Thor Motor Coach Recall Repair Instructions

| Recall # | 19V-566 2019-374 | | |
| Description/Title: | MORryde Battery Tray | | |
| Affected Product Line(s): | Certain MY 2019/2020 Magnitude & Omni motorhomes | | |

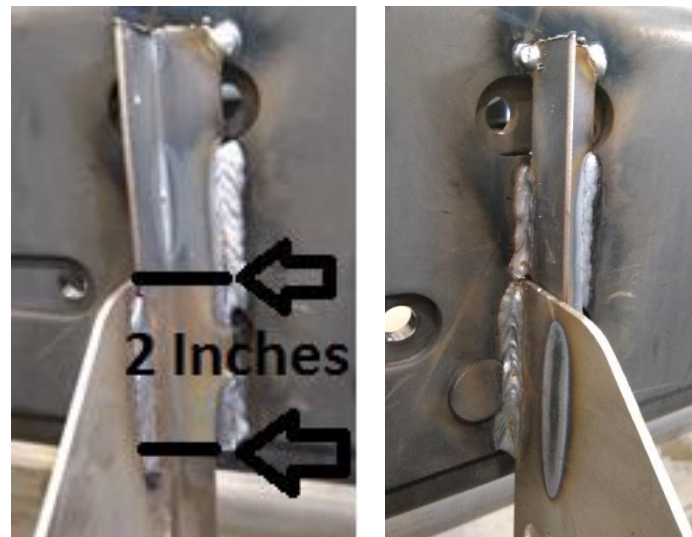
1. Open the hood and disconnect the positive and then the negative battery cables on both batteries. Once batteries have been disconnected, unclip all three harnesses on the electronic control module.
